**ADDENDUM
NO. 02**

**Franklin Central High School Addition and Renovations Phase 3A.1
6215 S. Franklin Rd
Indianapolis, IN 46259**

ADDENDUM NO. 2 (TWO)

DATE: March 28, 2025
PROJECT: Additions & Renovations to Franklin Central High School
Phase 3A.1
OWNER: Franklin Township Community School Corporation
PROJECT NO.: 2024040.00

Project No.: 2024040.00
Project Date: **FEBRUARY 27, 2025**
Drawing No.: **MP1H**

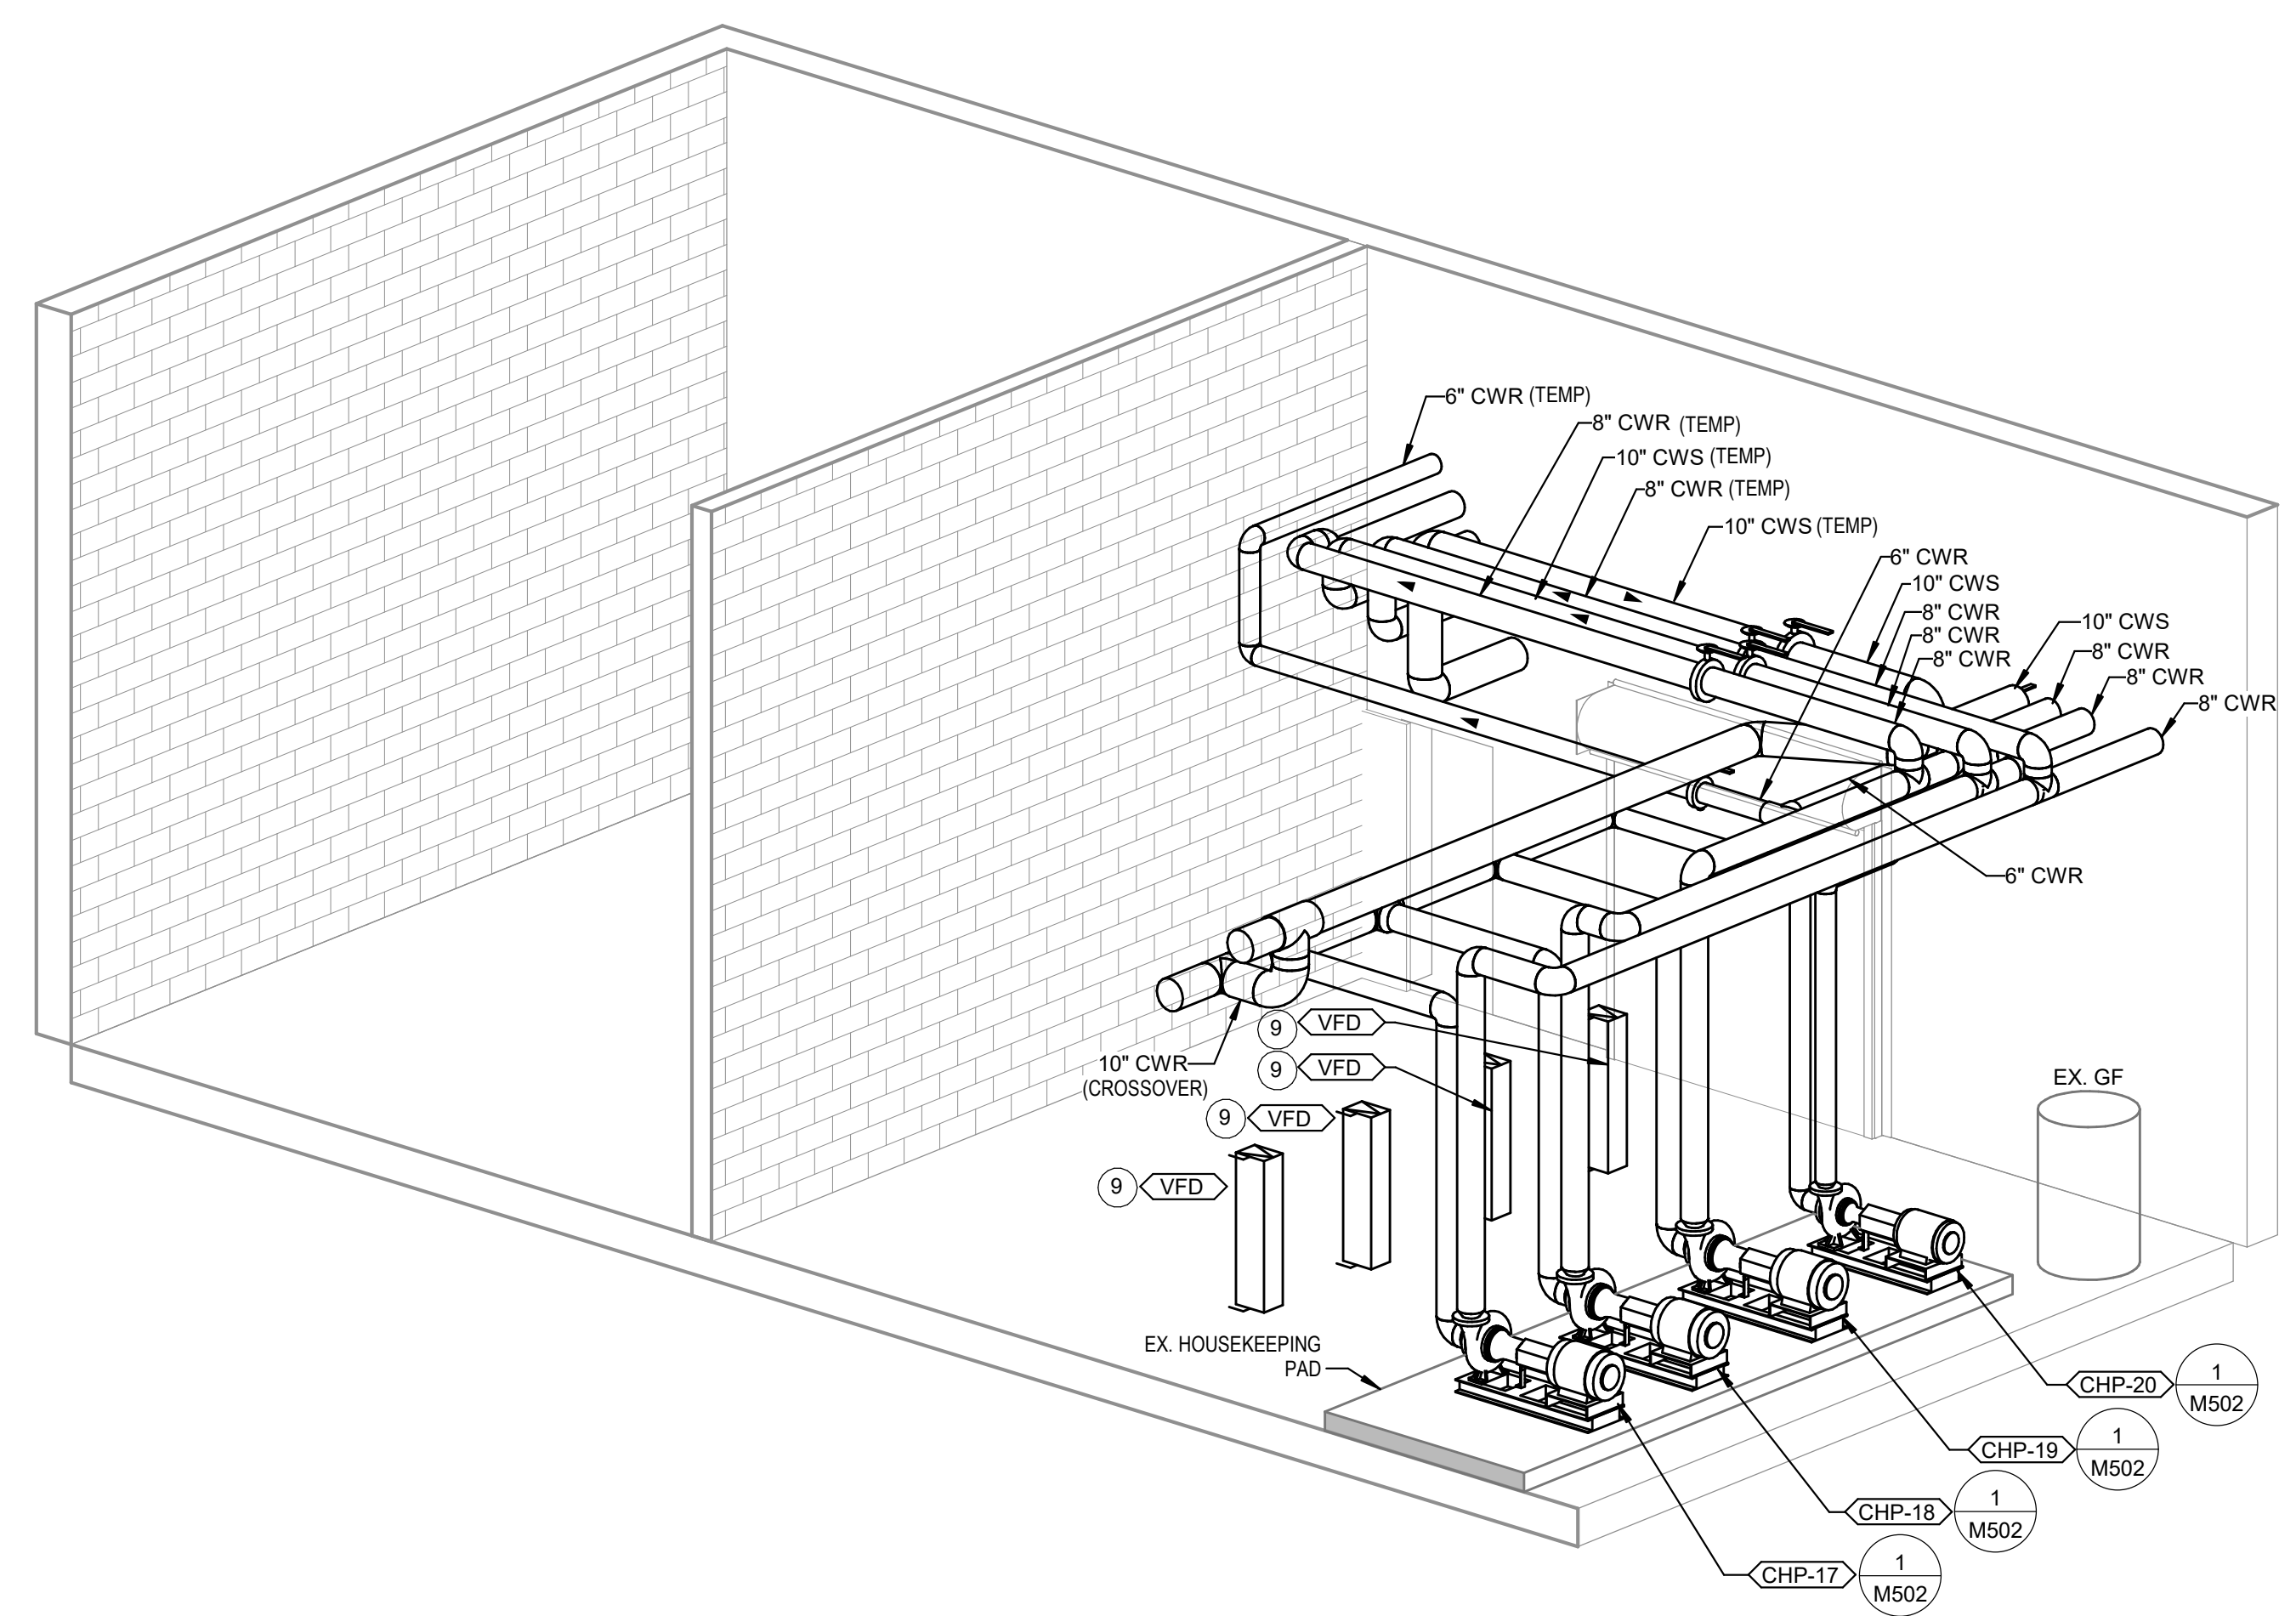
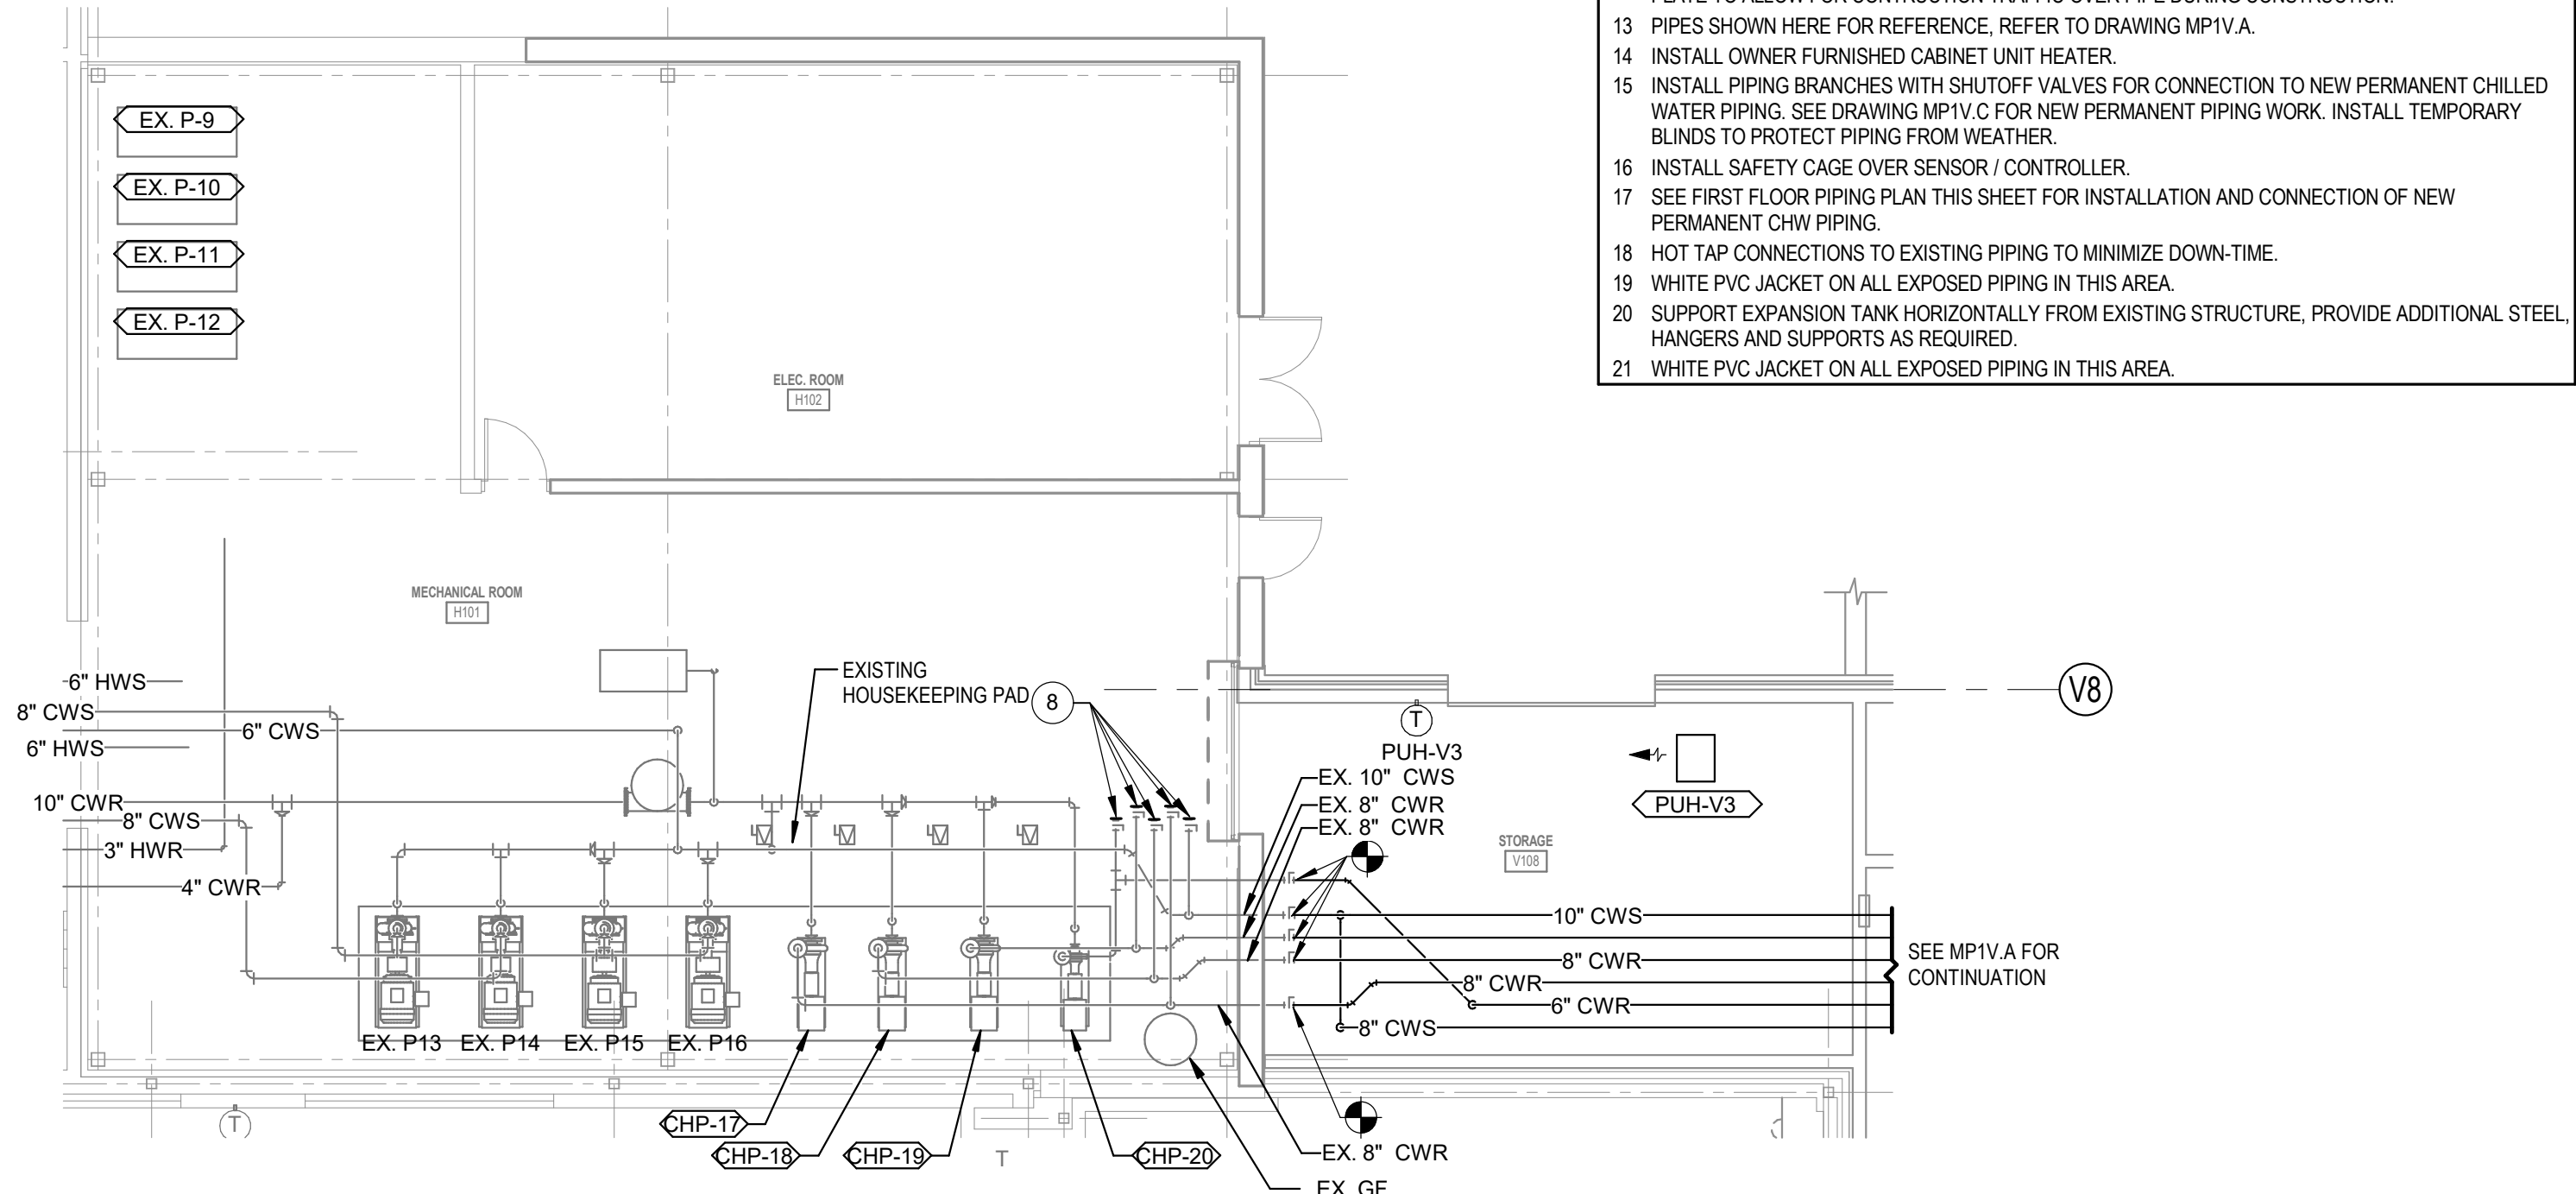
- 2-11 MP1H: Replace drawing in its entirety with attached revision.
- 2-12 MP1V.A: Replace drawing in its entirety with attached revision.
